Attachment B

OEH Science Division

Review of Springvale and Angus Place Mine Extension EISs

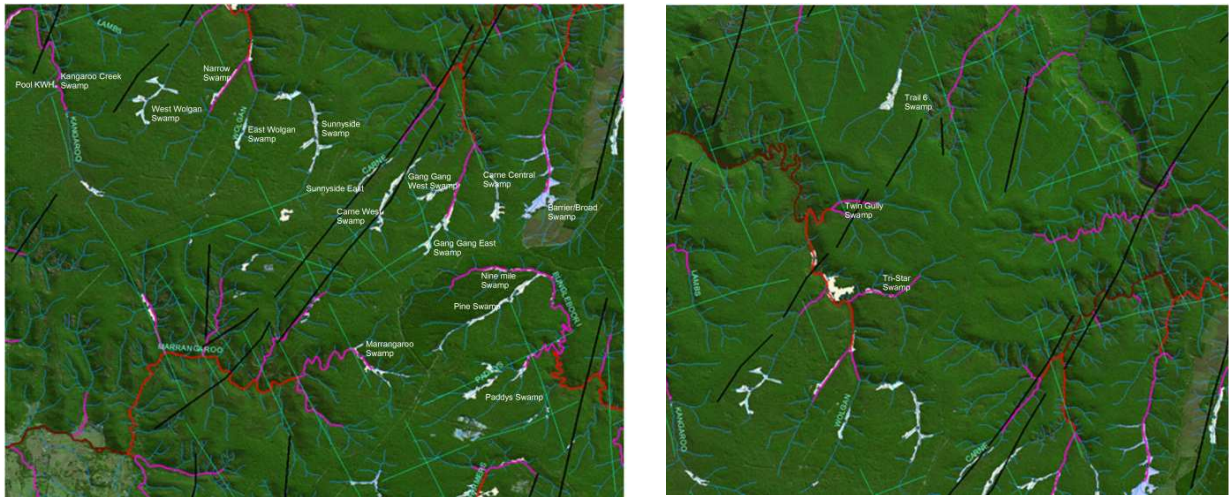
For Springvale, MSEC 2014a only discusses Wolgan River and Carne Creek specifically, with all other streams included under the generalized term “drainage lines”. This is despite 3rd order stream sections occurring within and downstream of Gang Gang East and Marangaroo Creek swamps which will be directly mined beneath (see Figure 1).

OEH considers that these streams have the potential to be fractured and drained. OEH notes no detail or specific predictions for these 3rd order streams (apart from point estimates for swamps) or any commitment to remediate these 3rd order streams if impacts occur. It is highly likely that fracturing of bedrock under the swamps and drainage of perched aquifers will also lead to a loss of flow in these 3rd order streams (see Figure 2 for the flow coming out of Gang Gang East Swamp on 26 May 2014, despite the seasonally unusual warm weather patterns prevalent at the time). There is no appropriate monitoring of flow in these streams which is capable of testing the veracity of the claims made in the EIS of no impact to flows.

For Angus Place mine, MSEC 2014b also only discusses Wolgan River and Carne Creek specifically with all other streams included under the generalized term “drainage lines”. This is despite 3rd order stream sections occurring above, within and

downstream of Twin Gully and Tri-Star swamps which will be directly mined beneath (see Figure 1).

OEH considers that these streams have the potential to be fractured and drained. OEH notes no detail or specific predictions for these 3rd order streams (apart from point estimates for swamps) or any commitment to remediate these 3rd order streams if impacts occur. It is highly likely that fracturing of bedrock under the swamps and drainage of perched aquifers will lead to a loss of flow in these 3rd order streams. There is no appropriate monitoring of flow in these streams which is capable of testing the veracity of the claims made in the EIS of no impact to flows.

Figure 3. Longwall mining impacts on piezometer levels in Swamp 1b (undermined; black line) compared to reference swamps (Den14 – blue line; Gallhers Tributary [“Leech”] Swamp – red line) . Source: Krogh (2013).

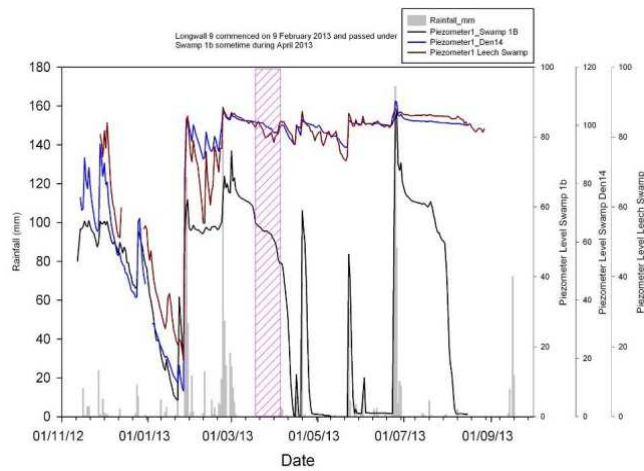
This is of concern as MSEC completed the last two end of block reports for Dendrobium (LW7 & LW8) and should be aware of documented and unequivocal impacts to coastal upland swamp EEC aquifers above the Dendrobium mine (eg Heritage Computing 2012, 2013; see also Krogh 2012). OEH has also recently been monitoring swamps above Dendrobium mine and these data demonstrate unequivocal swamp impacts due to the Dendrobium mine on Swamp 1B [drainage of perched aquifer in the swamp, increased desiccation (loss of soil moisture) of peaty sediments and lack of flow to the creek at the bottom of the swamp (Krogh 2013, see Figures 3-5)]. Similar impacts have also occurred at Swamp 15b, Swamp 1A, Swamp 5 and possibly Swamp 8 (e.g. Heritage Computing 2012, 2013; BHPBIC 2013).

Figure 6. Longwall mining impacts on groundwater levels within Kangaroo Ck Swamp (Red Line) compared to natural water level fluctuations in a reference swamp (Sunnyside Swamp; blue line), rainfall (vertical grey bars) and rainfall deficit (Black line). Source: DECCW 2010.

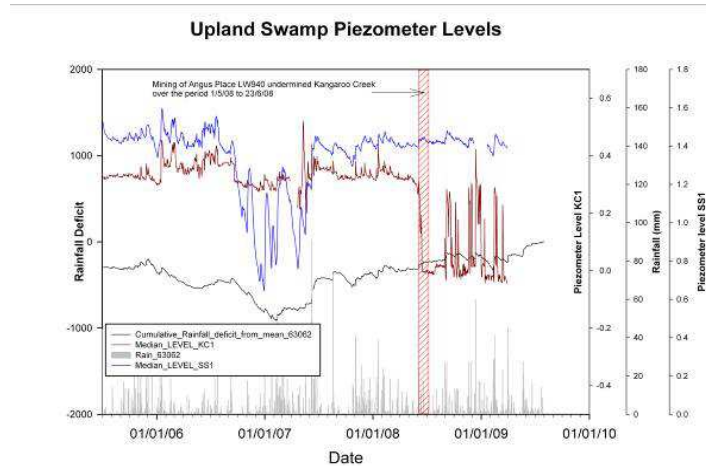
Section 5.12.3 of the Subsidence Impact Assessment detailing the history of mining beneath Angus Place and Springvale Collieries also omits any discussion of the mining impacts to Kangaroo Creek Swamp⁷ (Figure 6) or its upstream “permanent” waterhole KWH (Figures 7 & 8). The EIS reports also neglect to point out that LW940 was 262m wide and yet mining of this longwall still led to the loss of the permanent perched aquifer in Kangaroo Creek Swamp.

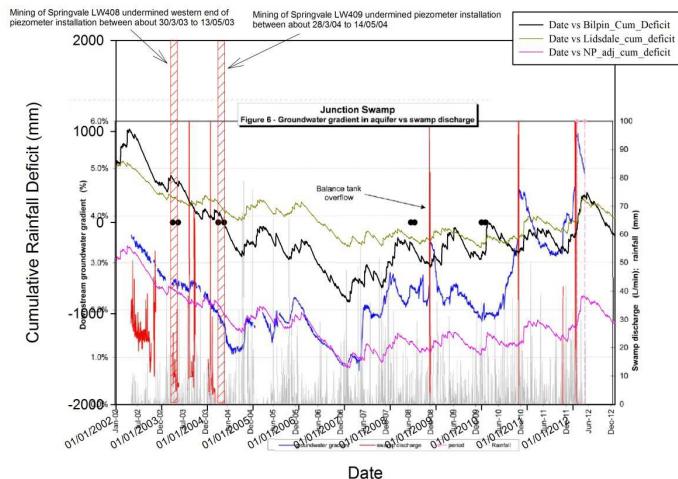
MSEC provide no scientific evidence that diverted surface water re-emerges in the catchment. Water drainage from East Wolgan Swamp was stated to have moved down to 70m (Aurecon 2009). There is also no mention in the EIS of the flow monitoring at Junction Swamp or explanation for why, post-mining of LW409, there has been virtually no flow in the creek line below Junction Swamp, except after heavy rain or a “balance tank overflow” (Figure 13). It is probable that flows in the creek line were once reasonable to warrant the size of the V-notch weir installed below Junction Swamp (Figure 13).

While there is little to suggest that LW408 impacted flows from Junction Swamp, no flow was recorded at the v-notch weir downstream of the swamp after the passage of LW409 and for approximately 6 years afterwards (discounting the balance tank overflow). Apart from the “balance tank overflow” [minewater?] around December 2008, some (assumed) rainfall related spikes in flow appear to have occurred close to December 2010, November 2011, and around March-April 2012. The recession of flows at these latter periods are very different (very abrupt) compared to pre-mining data. This is similar to what has actually been measured downstream of Swamp 1b after it was directly undermined and impacted by Dendrobium LW9 in the Southern Coalfields (Krogh 2013).

Figure 14. Water levels monitored in Carne Creek (CWP Waterhole). Source: RPS 2013.

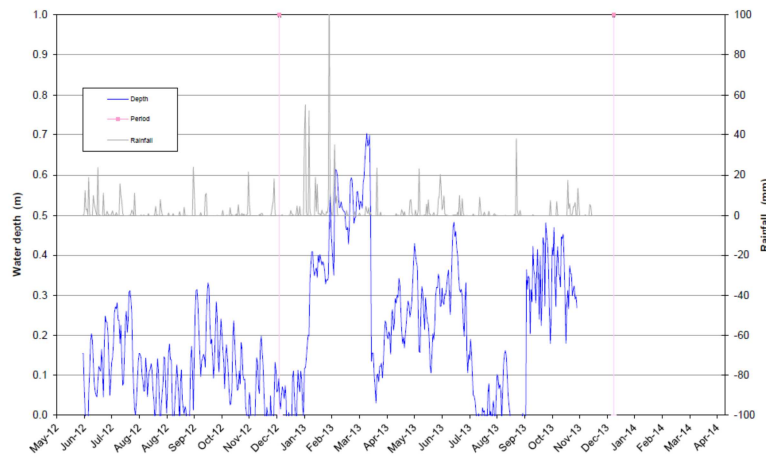
OEH believes that further consideration of pool recession rates might lead to a different conductance assumption for Pool KWH which could then potentially be used to model impacts in other areas of the model domain (ie in the swamps and streams directly above the proposed longwalls). Unfortunately Adhikary and Wilkins (2013) appear to accept that the spring above Pool KWH has not been affected based on "anecdotal evidence". As mentioned earlier, at OEH's last visit (May 2014) the spring was no longer flowing and Pool KWH was empty (as was the dam upstream). OEH has additional concerns about Adhikary and Wilkins (2013) assuming Carne West Swamp has ephemeral flows to CA4. OEH has consistently found water flowing from the downstream end of Carne West Swamp. Such a flow is supported by the relatively constant saturation of swamp sediments (high water level measured in lower Carne West Swamp piezometers). It is also supported by flow monitoring (by Aurecon 2011 [fortnightly pigmy flow meter records] and RPS 2013 [pool depth monitor, frequency not stated, but potentially daily or less; see Figure 14]).

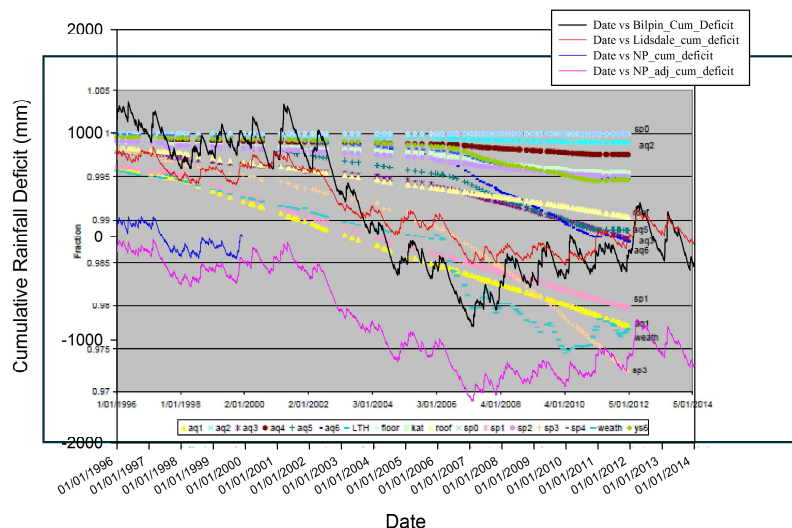
While there appears to be some relationship with rainfall deficit, the response suggested for the modelled response of the weathered zone appears to be much more complicated than a simple correlation with rainfall deficit – see Figure 15. For example, the model output appears to become increasingly sensitive to rainfall deficit as time (and presumably extent of mining) increases. Declines in water levels within the weathered zone could actually have important implications for NPSS and baseflow to streams. It would be interesting to see if this modelled effect is real or a function of model assumptions.

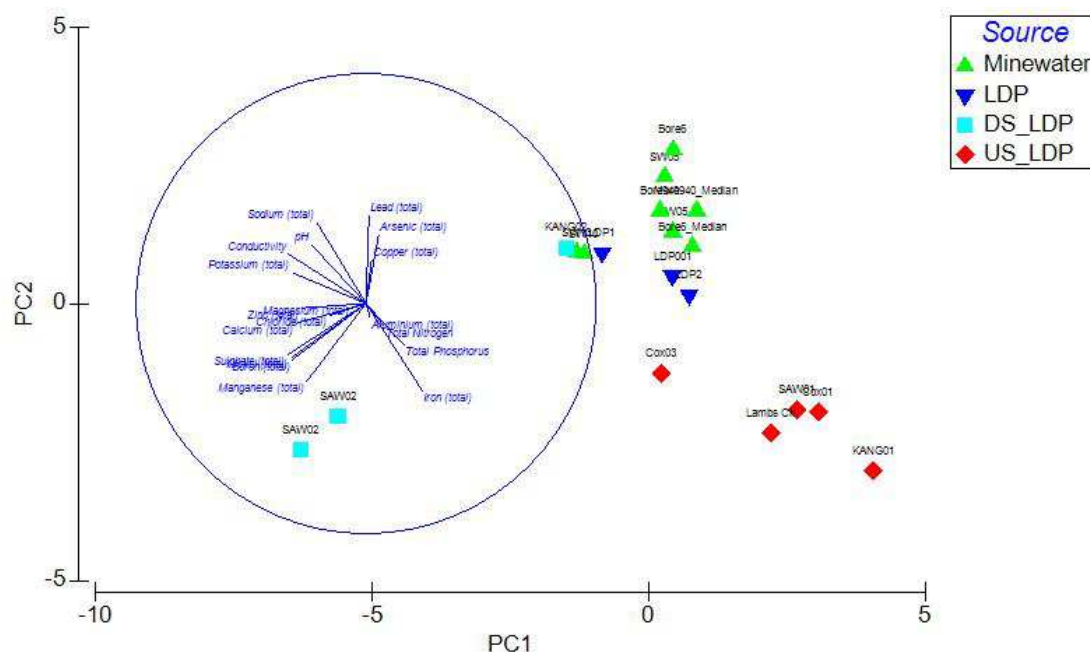
Rather than decrease the impacts of highly saline minewater on the environment in the Upper Coxs River catchment, the Proponent is currently proposing to release a very large volume of high salinity, high metal concentration minewater to the Coxs River catchment for the next 30 years. Rarely is the water quality from the LDPs contrasted with appropriate upstream sites, however if this is undertaken using available data there is a clear separation of minewater, LDP discharge water and upstream water quality sites (Figure 17). Similar results were found for the broader Upper Coxs River catchment (e.g. see Krogh and Miller 2011, GHD 2010).
